**HEBER CITY CORPORATION
75 North Main Street
Heber City, UT 84032
Planning Commission Meeting**

MEETING DATE: 1/23/2024
SUBJECT: Request for Preliminary Subdivision approval for Jordanelle Ridge Village 2 - Fitzgerald (Planner Larsen/Engineer Mumford)
RESPONSIBLE: Aubrey Larsen
DEPARTMENT: Planning
STRATEGIC RELEVANCE: Community Development

1. 1-Jordanelle Ridge Village 2 Fitzgerald SUB. PRELIMINARY - Planner Checklist
2. 2-21001LT JRidge2 Fitzgerald PC Prelim Horrocks 240112
3. 3-JRV 2 Fitzgerald Sub Preliminary DRAWINGS and ATTACHMENTS

PLANNING REVIEW CHECKLIST

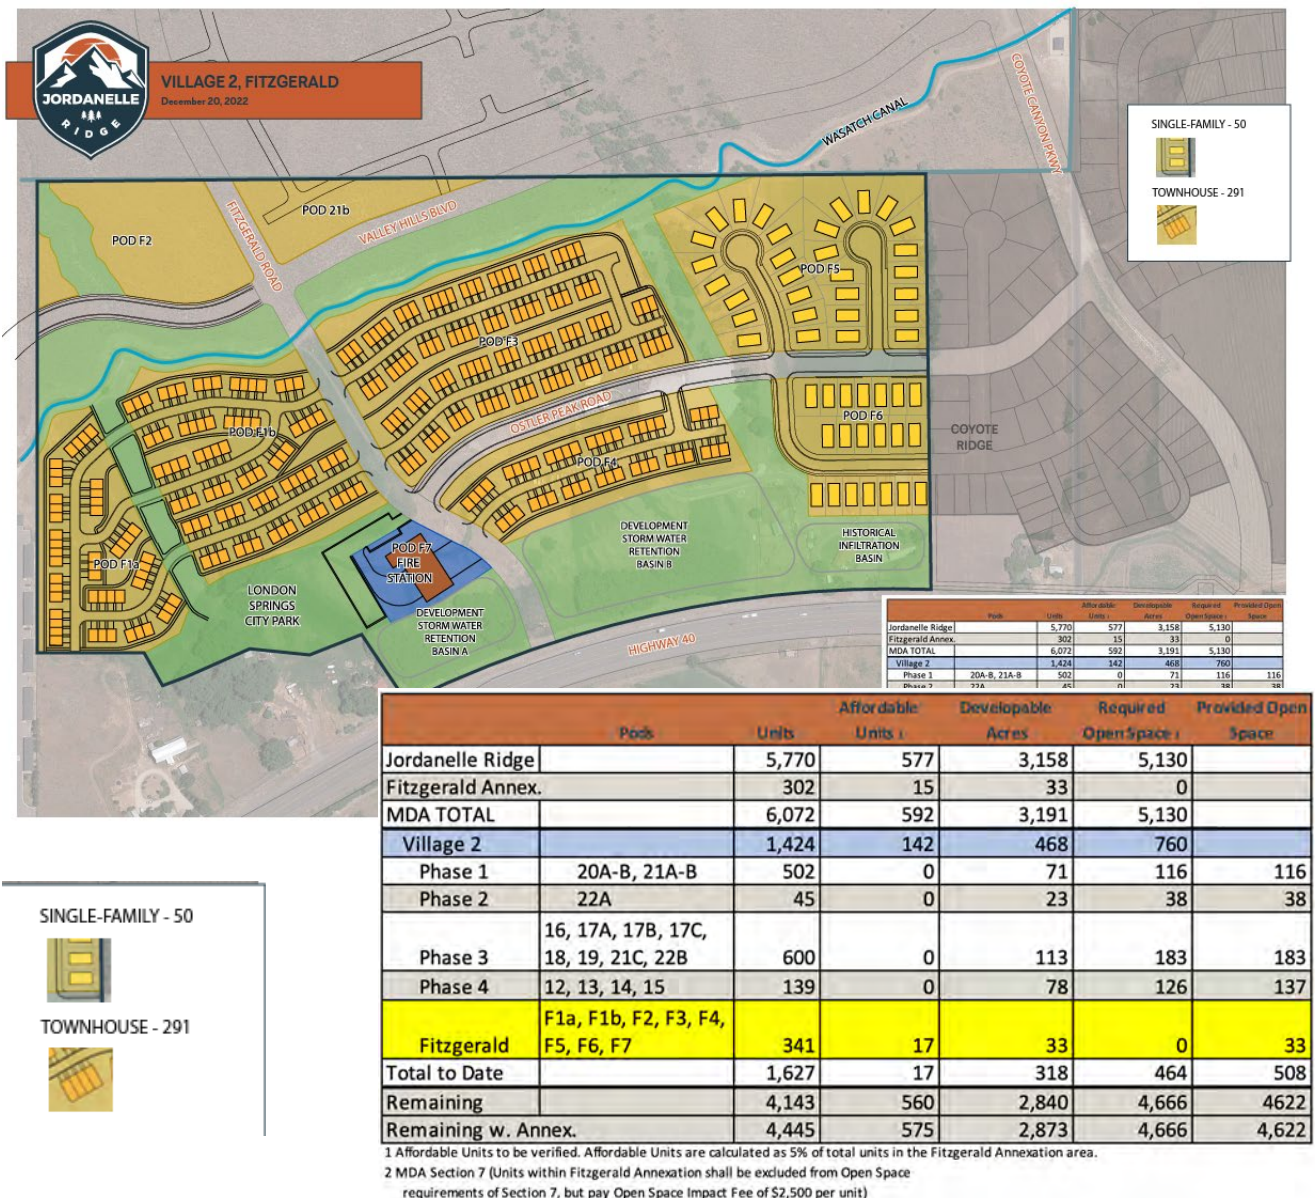
- The concept plan showed a slightly different unit total (50 single family and 291 townhomes). Civic Review indicates there will be 52 single family lots and 303 townhomes.

How many affordable units will be provided now? Open space? Please provide an updated site data table.

- As per 17.20.030 Preliminary Plans, the following items appear to be missing:
 - A title report for all lands proposed to be subdivided;
 - A Preliminary Environmental Impact Assessment (also brought up by engineering)
 - Water Action Report as required by Section 15.16.090
 - "Will Serve" letters from all serving utilities.
 - Affordable Housing Plan as required by Section 18.102.030.
